March 12, 2025  
SCS Project No. 16224067.00

Subject: City of Uvalde MSW Landfill - Uvalde County  
Municipal Solid Waste - Permit No. 1725  
Permit Modification Application – Landfill Gas Management Plan  
RN102803921 / CN600648455

In response to your June 30, 2024 email, the following summarizes the revisions made to the LGMP, as described below in response to your questions/comments:

FIGURE 1.1

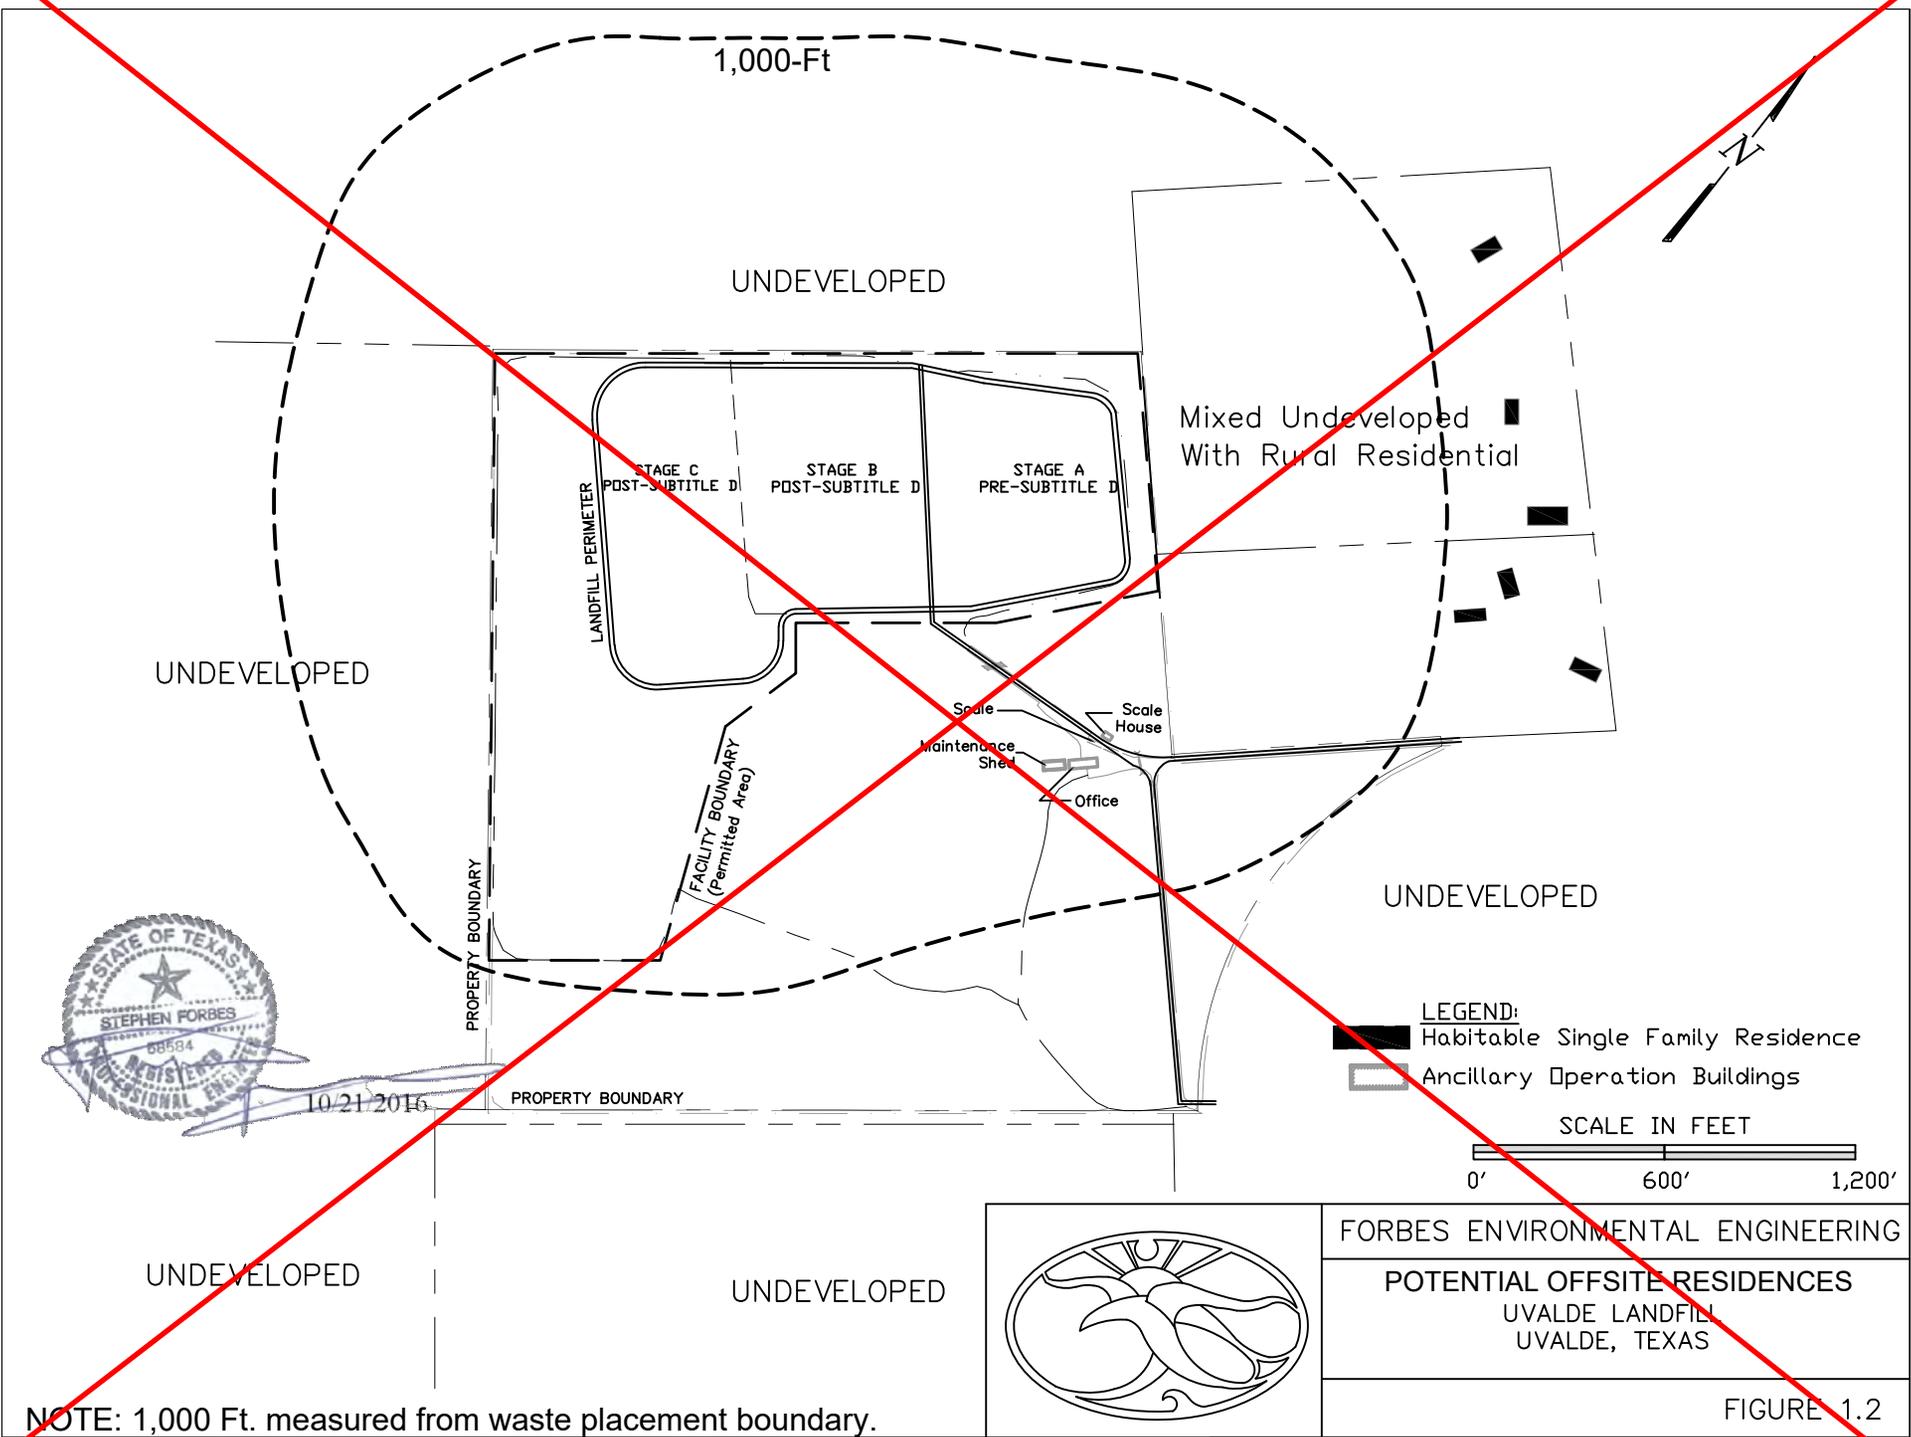
- A11. [Figure 1.1] Is this City of Uvalde? Label to provide a point of reference on the map.

***Figure 1.1, USGS Site Location Map, has been replaced to include identification of the City of Uvalde for a point of reference.***

FIGURE 1.2

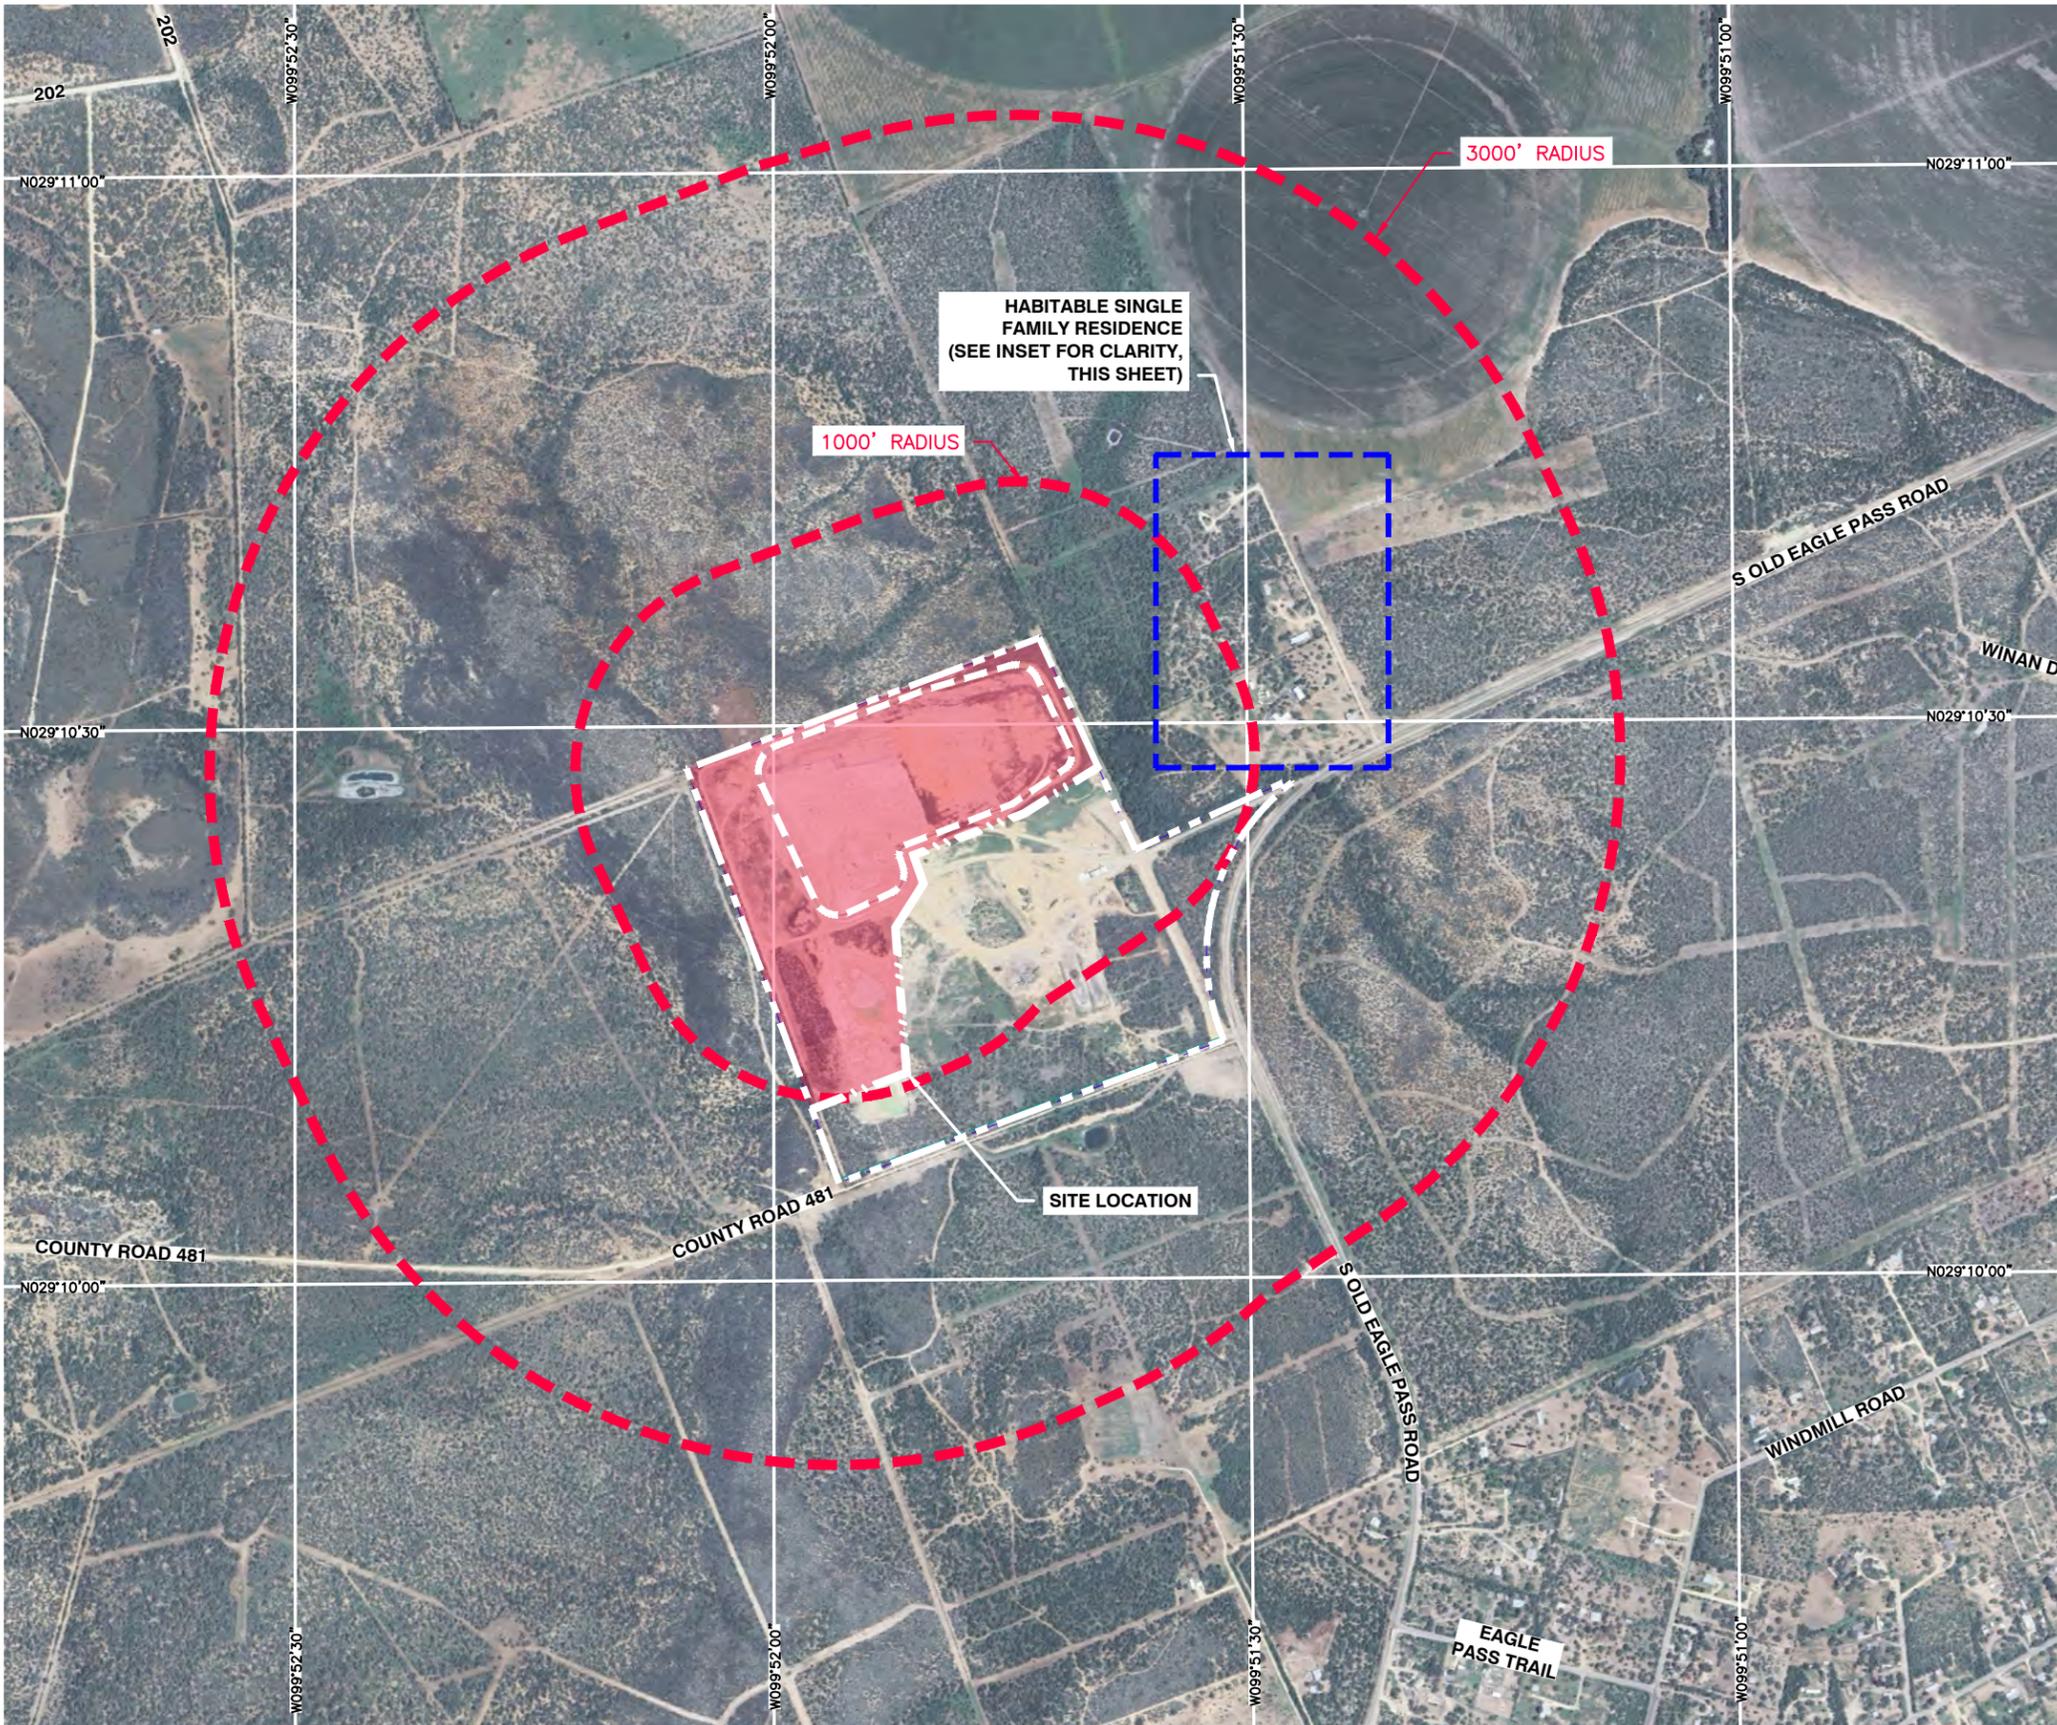
- A12. [Figure 1.2] The location of these structures does not quite seem to match current, as seen in aerial photo, and one may be within 1,000 ft of waste unit boundary.

***Figure 1.2 has been replaced with an aerial version to depict any habitable structures within 1,000 feet and 3,000 feet of the waste placement boundary. The closest structure is just outside the 1,000-foot boundary.***

FIGURE 1.3

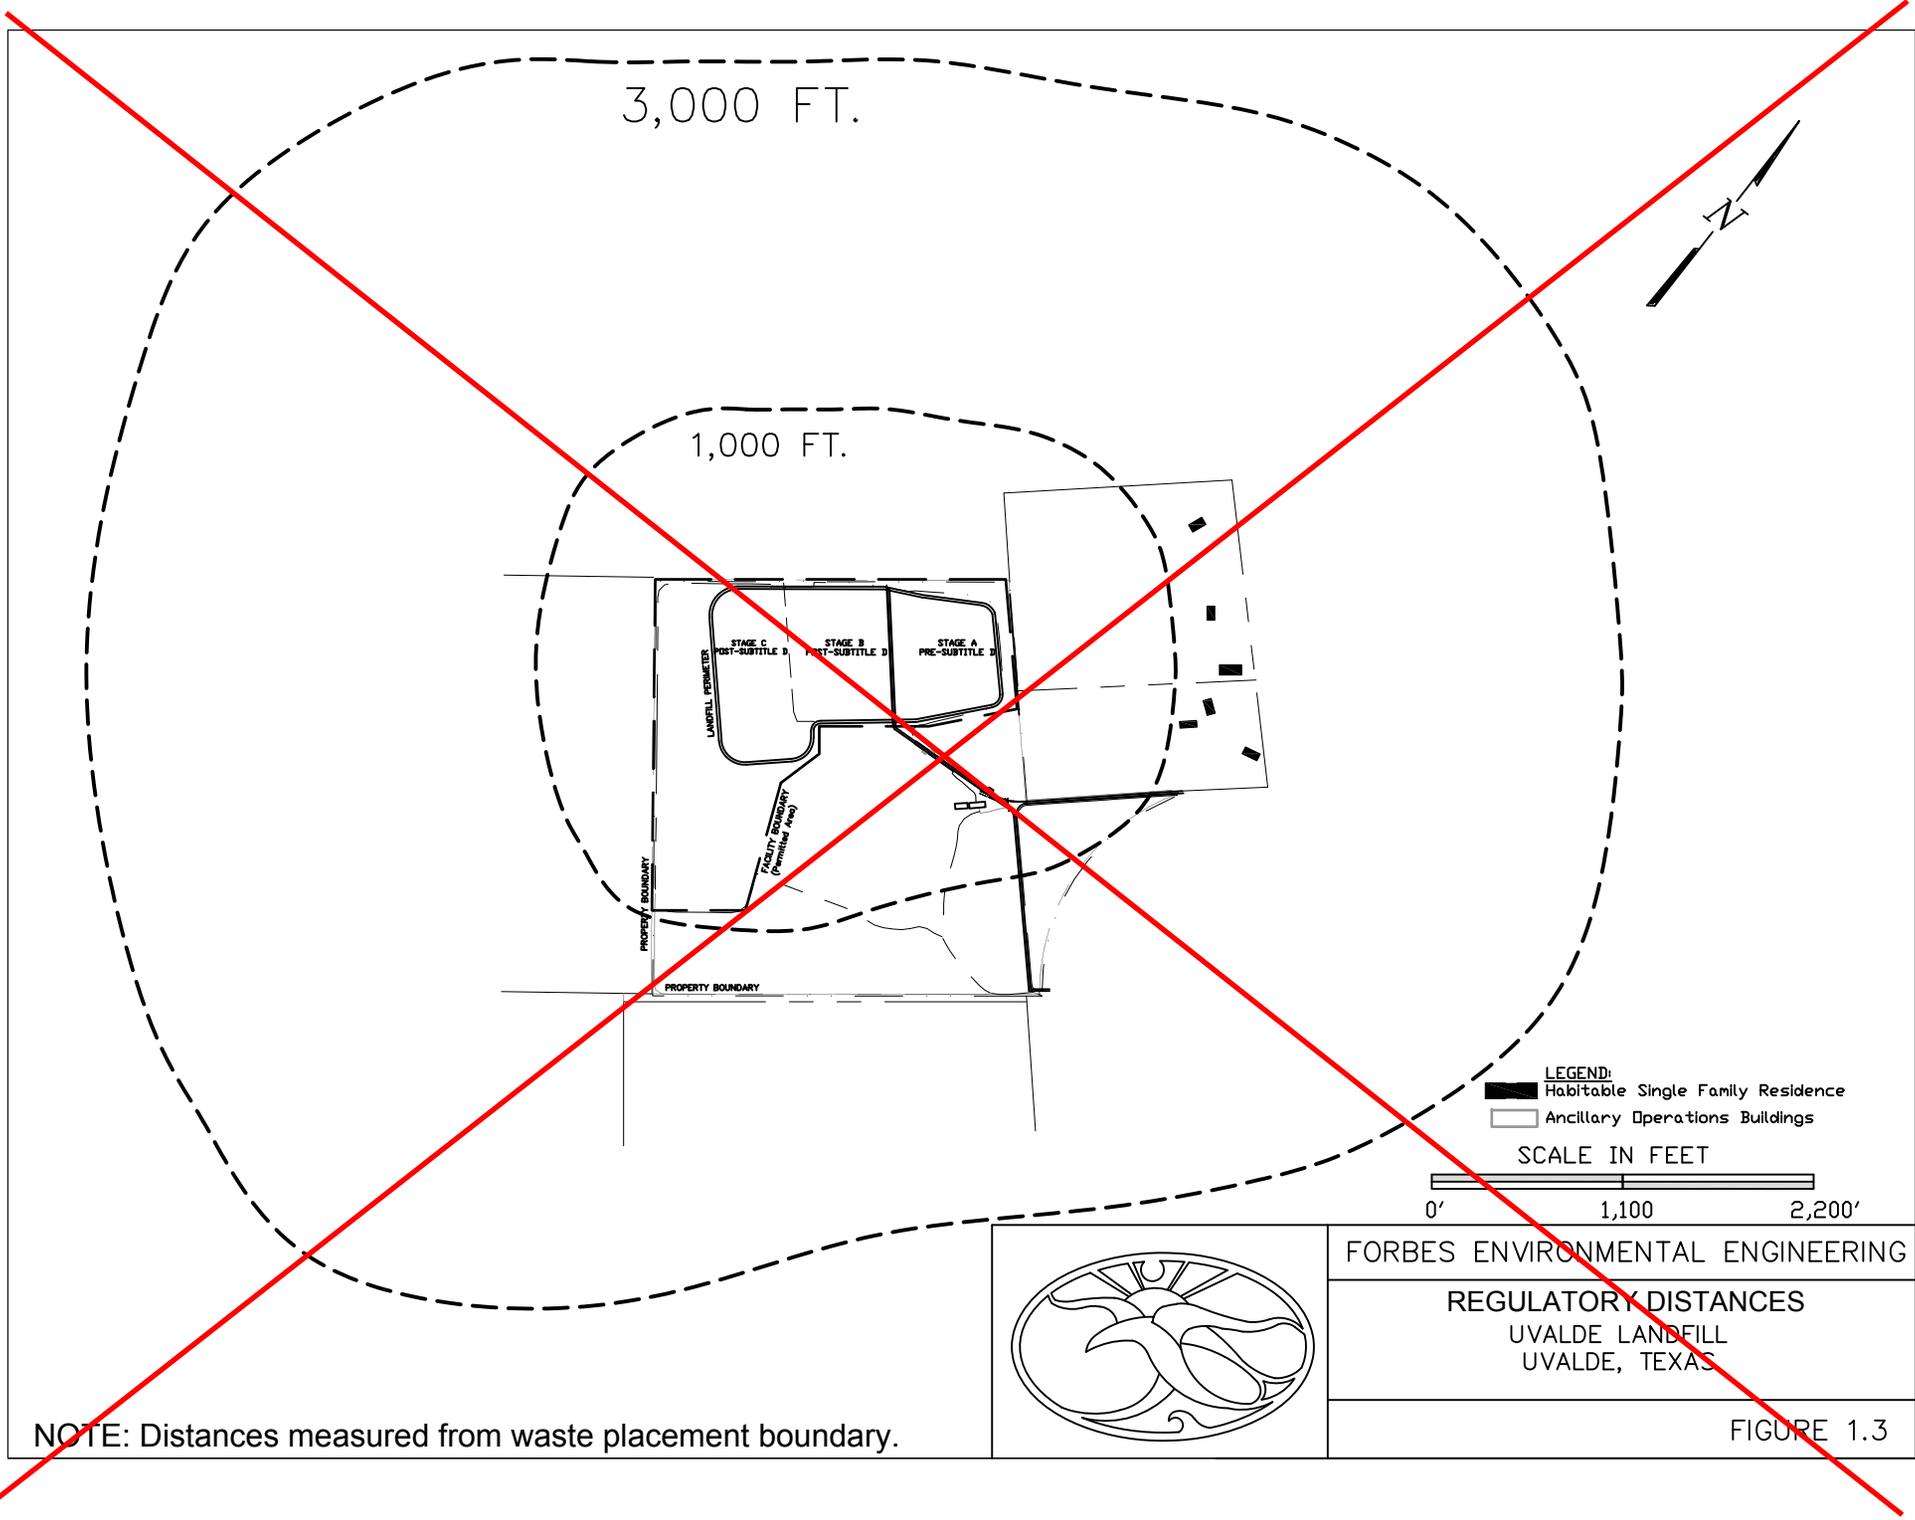
- A13. [Figure 1.3] Same comment re structures.

***Figure 1.3 has been removed from the LGMP and combined with the new Figure 1.2 referenced in the previous comment.***
